**RE: Baffinland Response to Comments
2018 QIA & NWB Annual Report for Operations
Mary River Project, Type 'A' Water Licence - 2AM-MRY1325 - Amend. No. 1**

Table 1-1: Baffinland Responses to 2018 QIA-NWB Annual Report for Operations

Figure 1 – Proposed Confirmatory Sampling Locations

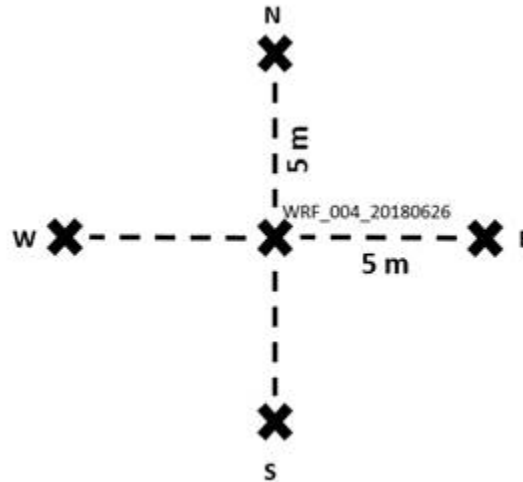
From QIA's inspection report dated 24 July 2018, two (2) samples were identified as Potentially Acid Generating (PAG) in an area understood by QIA to be used for storage of Non-PAG (NPAG) material. The samples were identified as:

- **WRF_004_20180626**
 - The split sample analyzed by Baffinland identified the same sample as NPAG. Given that these samples were split from the same rock, this is indicative of the heterogeneity and variability associated with the source material. Confirmatory sampling is required, as outlined further below.
- **WRF_018_20180626**
 - The split sample analyzed by Baffinland identified the same sample as PAG. Baffinland anticipated this sample to be characterized as PAG, as the location of the sample is on the scree slope of the PAG material placement area. No further action is required.

In order to further characterize the area associated with sample ID WRF_004_20180626, and reduce any uncertainty associated with the sampling technique or analysis, confirmatory sampling will be conducted to support the previous evaluation. A total of five (5) additional samples will be collected; one (1) at the initial sample location, and four (4) at a distance of 5m in each cardinal direction, as depicted in Figure 1.

Baffinland will work with QIA to find a suitable date for this sampling to be completed, such that a representative from QIA may be present to observe the sampling and/or collect paired samples.
